ECE/TRANS/WP.29/GRSG/2006/5
9 February 2006

PROPOSAL FOR DRAFT SUPPLEMENT 1 TO THE DRAFT 02 SERIES OF
AMENDMENTS TO REGULATION No. 107

(M₂ and M₃ vehicles)

Transmitted by the expert from the International Organization of
Motor Vehicle Manufacturers (OICA)

"Figure 1

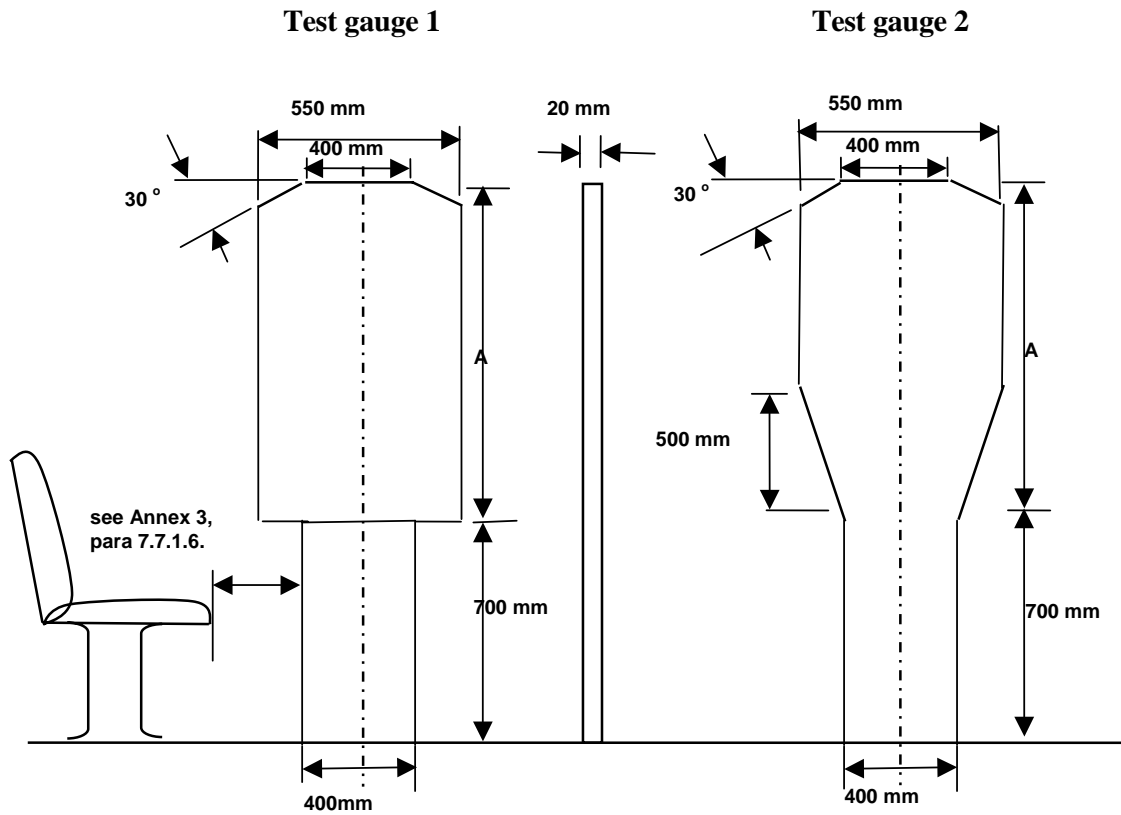
"7.7.1.1. The free space extending inwards into the vehicle from the side wall in which the door is mounted shall permit the free passage of **one test gauge having the dimensions of either test gauge 1 or test gauge 2 specified in Annex 4, figure 1.**

Figure 1, amend to read:

Vehicle class	Height of the upper panel (mm) (Dimension "A" figure 1)	
	Test gauge 1	Test gauge 2
Class A	950 */	950
Class B	700 */	950
Class I	1,100	1,100
Class II	950	1,100
Class III	850	1,100

*/ For vehicles of Class A or B, the lower panel may be displaced horizontally relative to the upper panel provided that it is in the same direction."

"Figure 11b

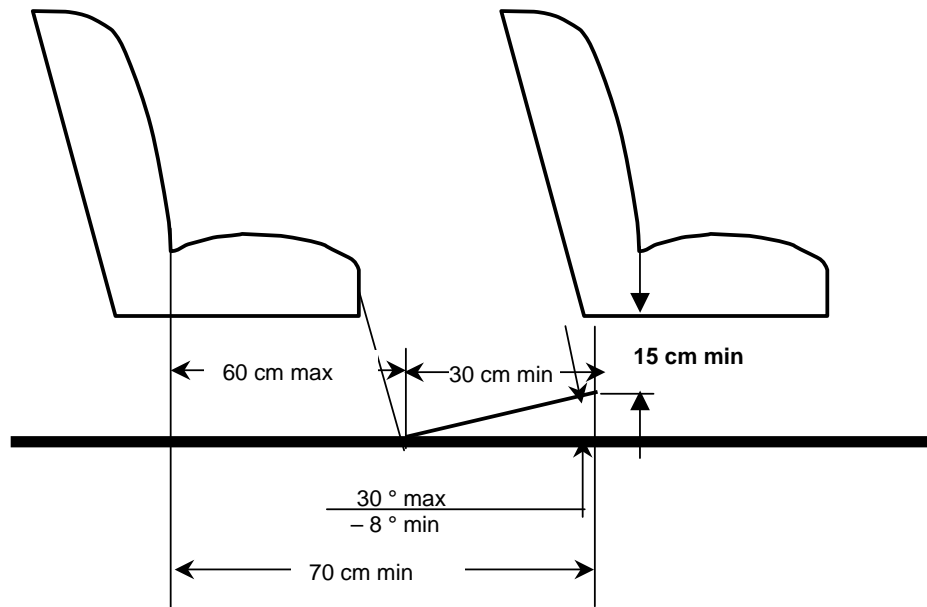
"7.7.8.5.2. **For a seat behind a seat and/or a seat facing the gangway, a minimum clear foot space of at least 300 mm depth and a width according to paragraph 7.7.8.1.1., shall be provided as shown in Annex 4, figure 11b. The local presence in this space of seat legs, passenger footrests and of intrusions as provided by paragraph 7.7.8.6. shall be permitted provided that adequate space remains for the passengers' feet. This foot space may partly be situated in and/or above the gangway but shall not create any obstruction when measuring the minimum gangway-width in accordance with paragraph 7.7.5. In the case of seats alongside the driver's seat in vehicles of Class A or B, intrusion of the seat belts and seat belt anchorages shall be allowed.**"

Insert a new Figure 11b, to read:

"Figure 20

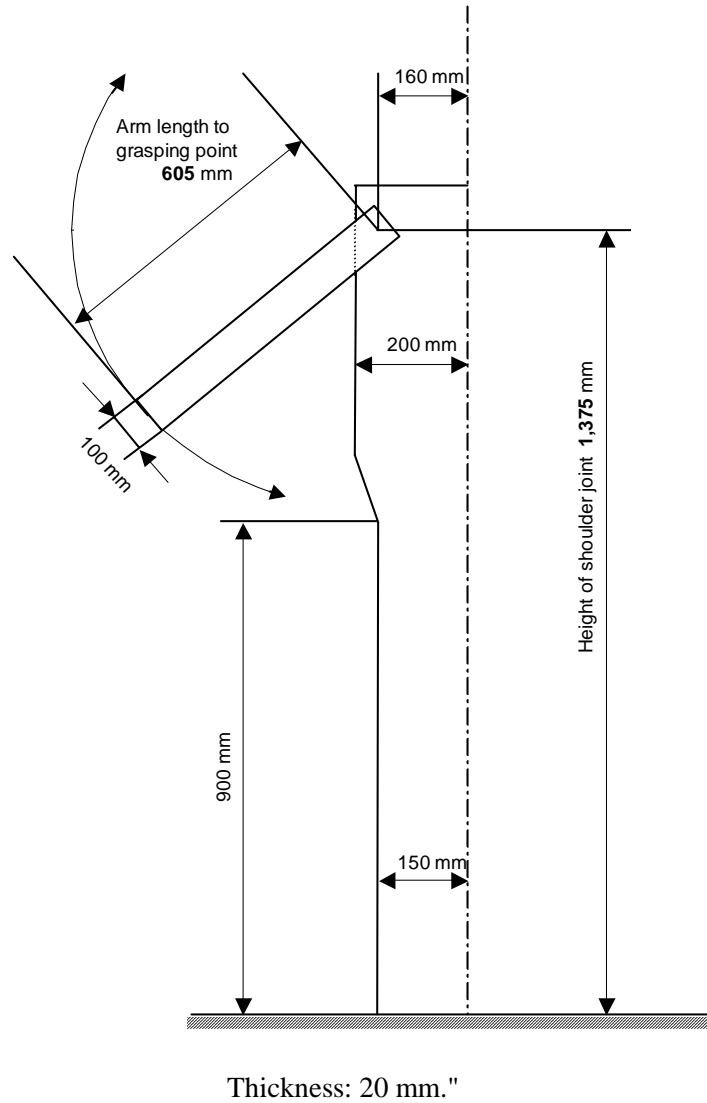
Figure 20, amend to read:

Figure 23 A

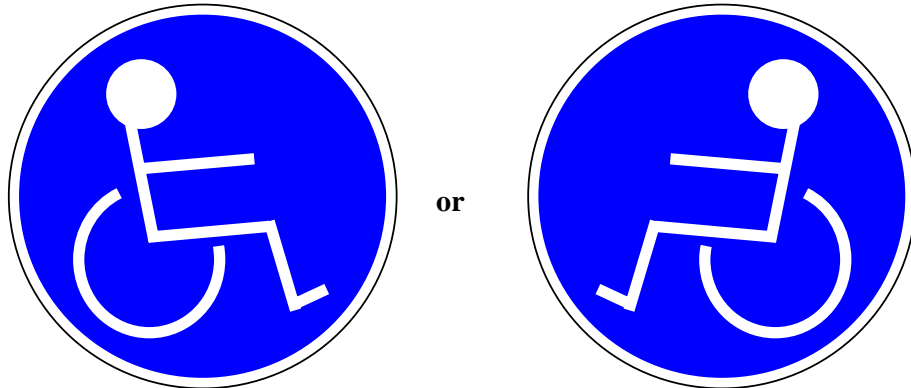
Figure 23, amend to read:

Pictogram for wheelchair users

Colour: blue basis with white symbol
Size: at least 130 mm diameter

"Figure 27

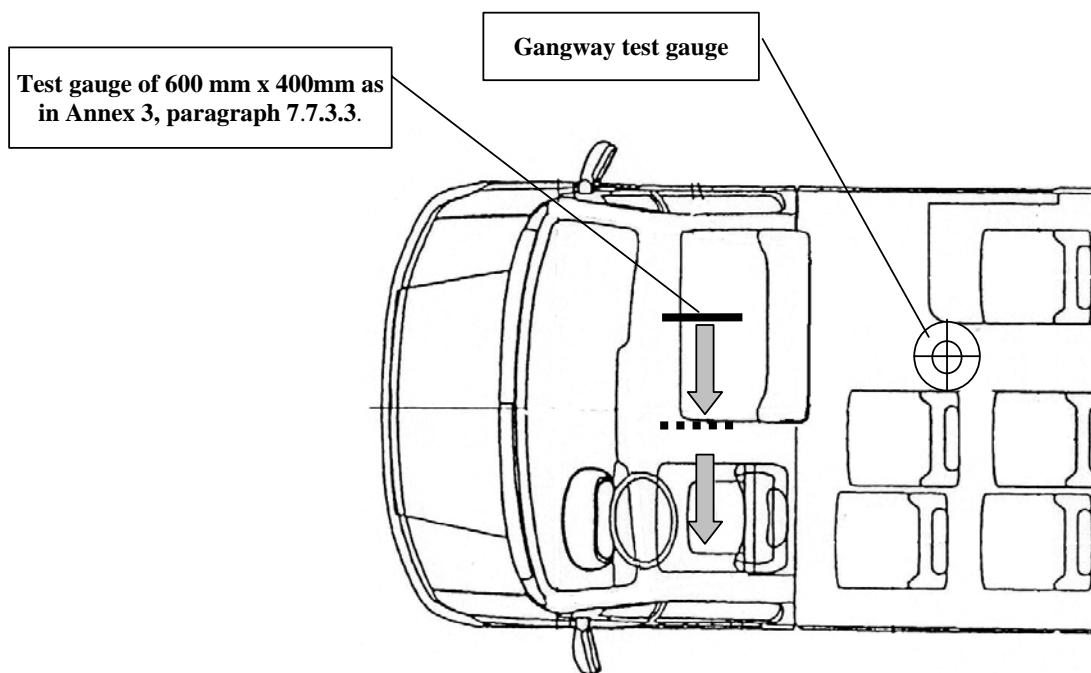
The driver's door shall be accepted as the emergency door for the occupants of those seats, provided that **it is possible to move a test gauge from the occupants' seats to the exterior of the vehicle through the driver's door (see Annex 4, figure 27).**

Insert new Figures 27 and 28, to read:

Figure 28

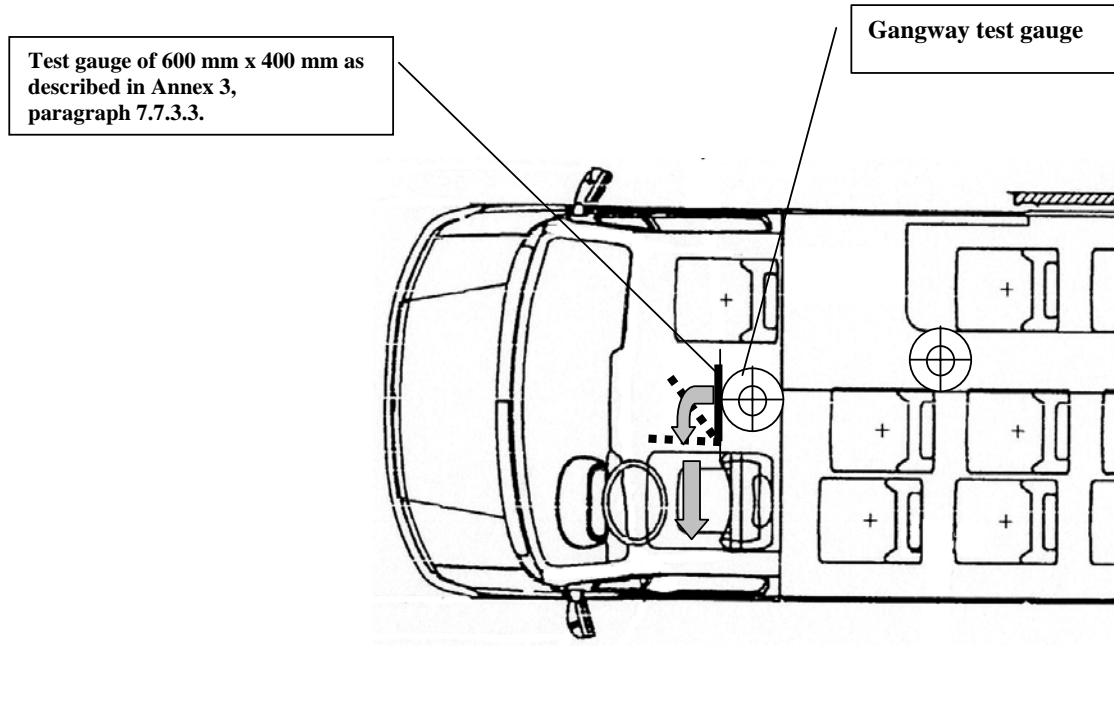
"7.6.1.9.3. the space reserved for the driver's seat shall communicate with the main passengers' compartment through an appropriate passage; such requirement shall be deemed to be fulfilled if the test gauge described in paragraph 7.7.5.1. can move unobstructed from the gangway, until the front end of the gauge reaches the vertical plane tangential to the foremost point of the driver's seat back (this seat being situated in its rearmost longitudinal position) and, from this plane, the panel described in paragraph 7.6.1.7.2. could be moved to the emergency door in the direction established by such paragraph (see Annex 4, figure 28) with seat and steering wheel adjustment in their mid position."
